**CHANGE ORDER FORM**

Change Order No. 01  
Project Title KWRU Filter & CCC Replacement  
Bid No. 02  
Owner: Key West Resort Utilities Corp.  
Contractor: Wharton Smith  
Agreement Date: 4/18/ 2018

Re: Change Order Proposal No. 01 Revision 1  
KWRU Filter Replacement  
Generator Replacement

# KWRU WWTP GENERATOR REPLACEMENT

PROPOSED GENERATOR FOUNDATION DETAILS

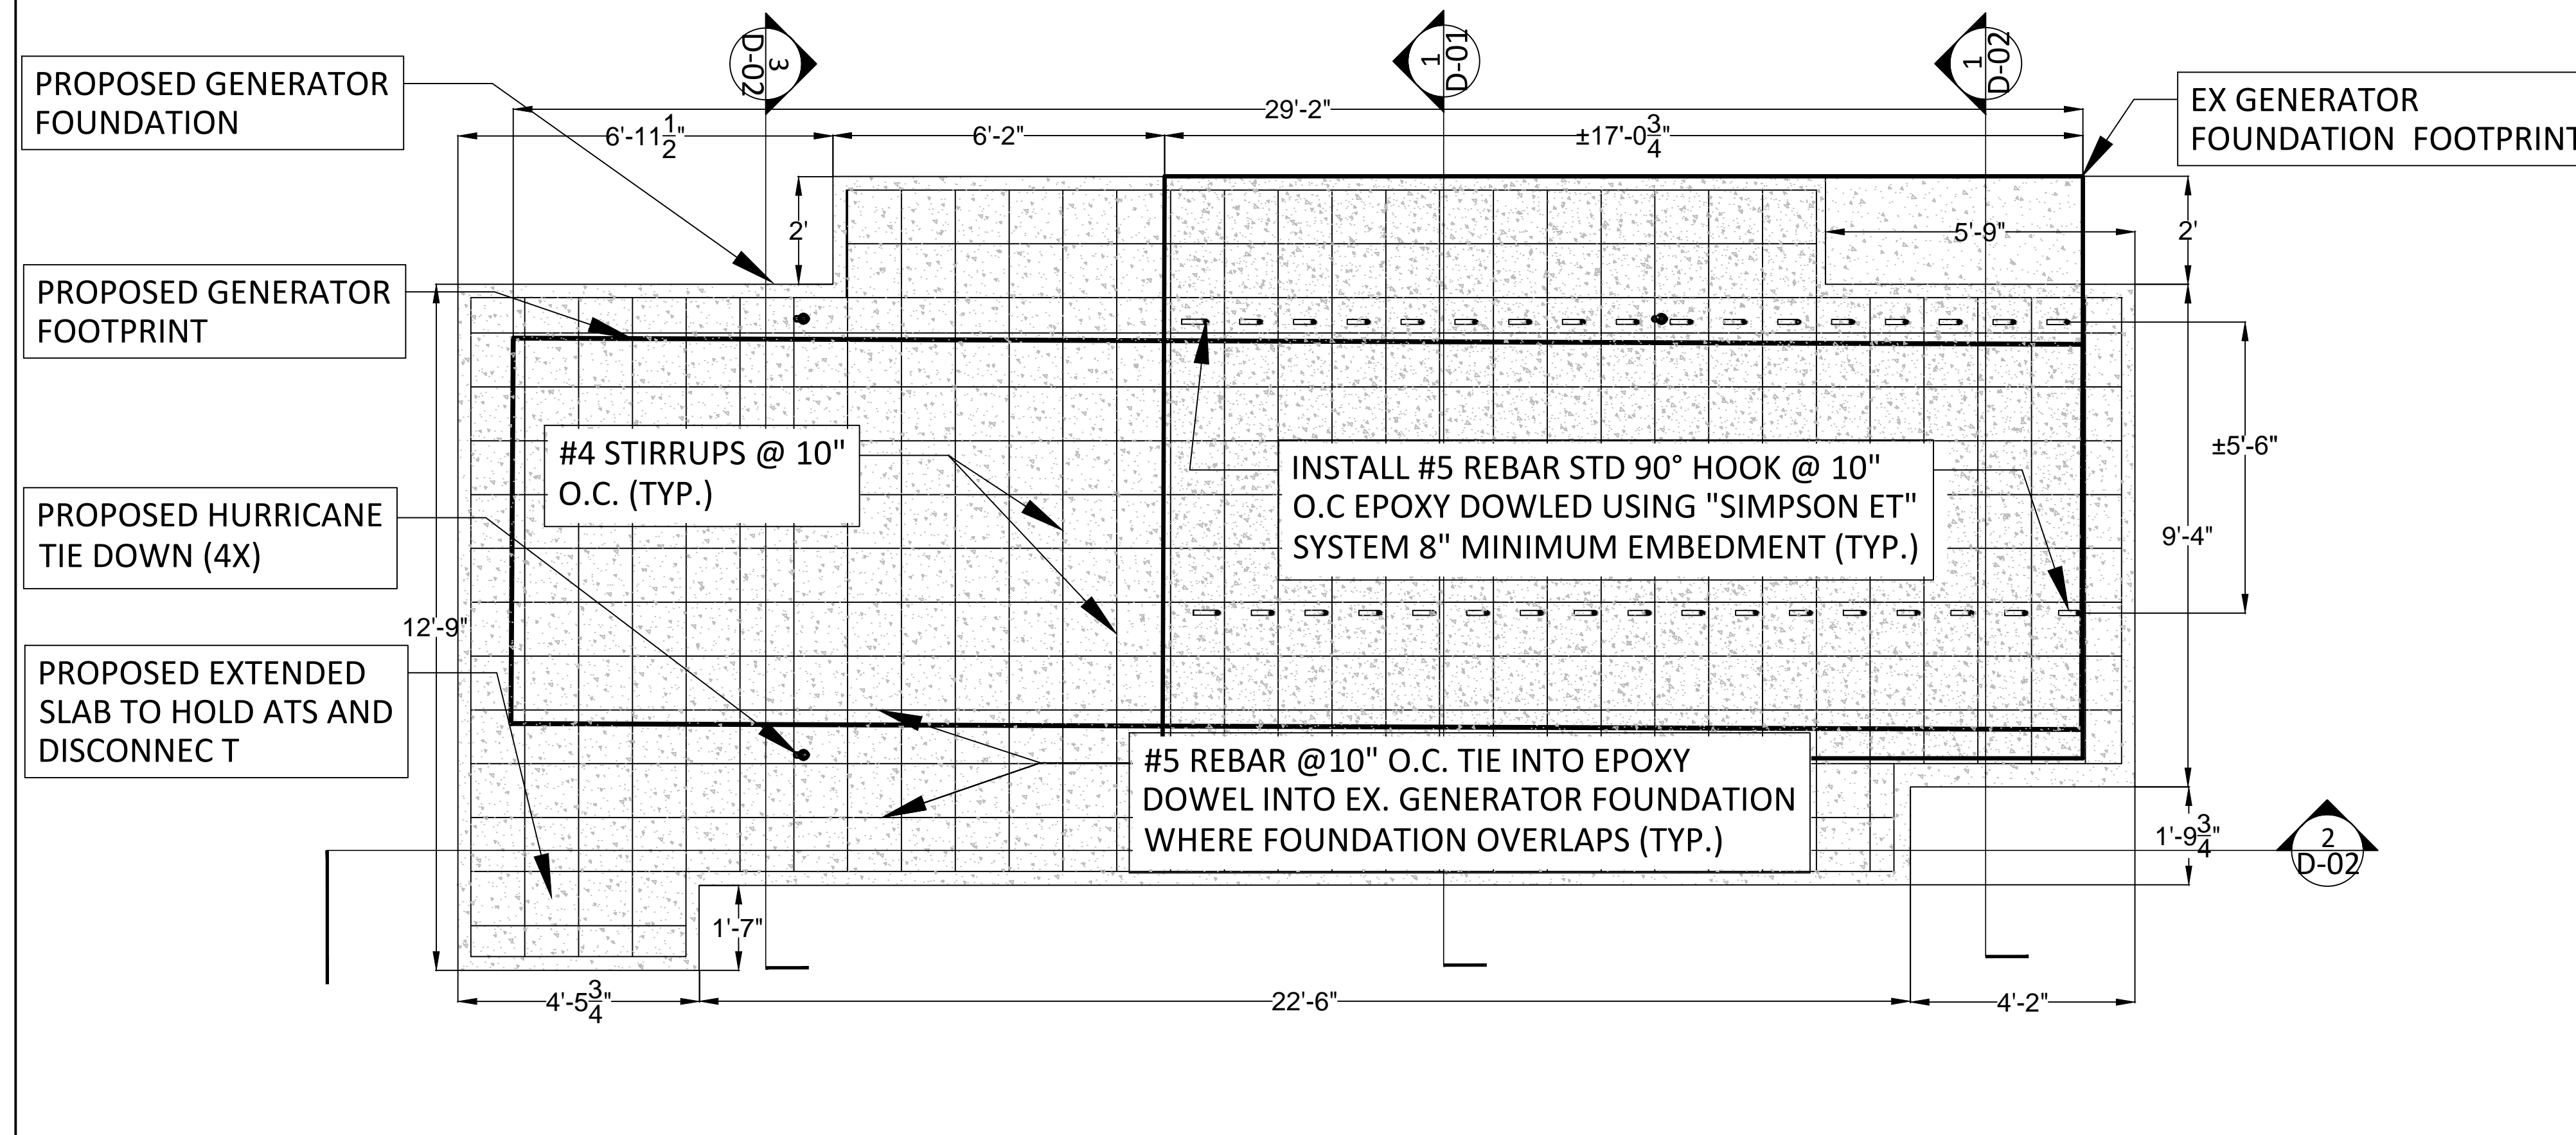
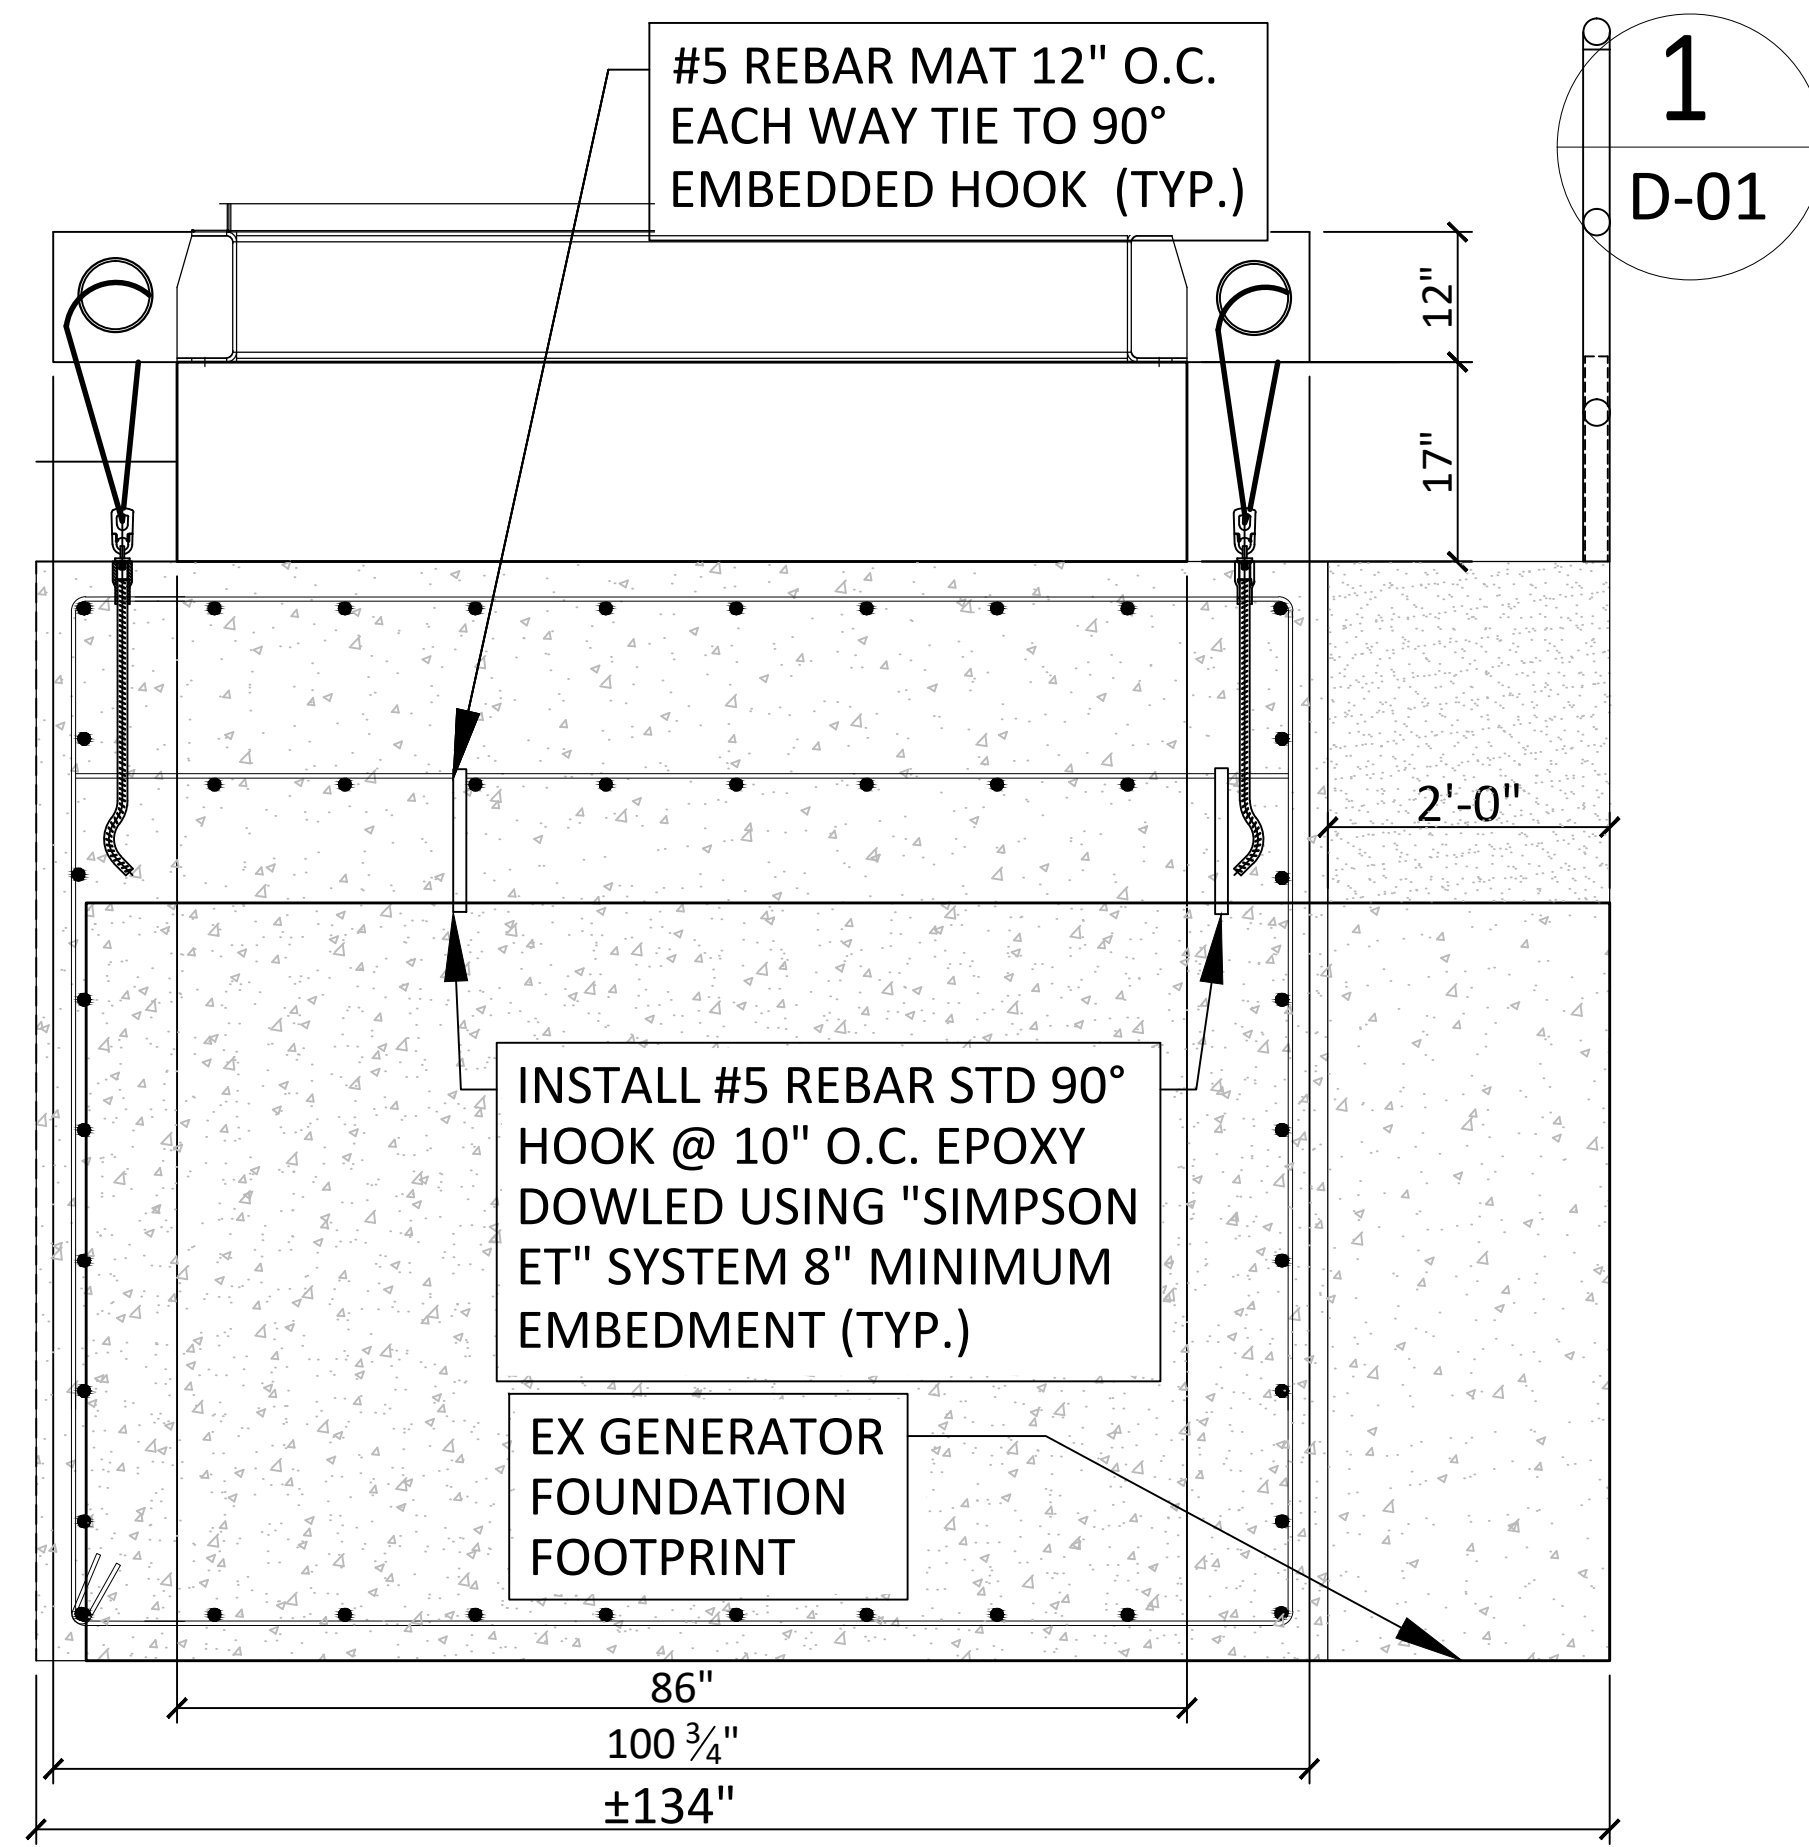
- Installation of modified generator foundation as shown and described in the attached plans.
- Coordinate delivery with Generator supplier and offloading of generator from freight shipper.

- Setting & installation of generator on modified foundation as shown in attached plans.
- Underlayment (like what is proposed for the filters) shall be installed between generator fuel tank and concrete.

- Supply and installation of generator tie-downs as shown on the attached plans including all misc. hardware.
- Installation of aluminum handrail as shown in the attached PDF.
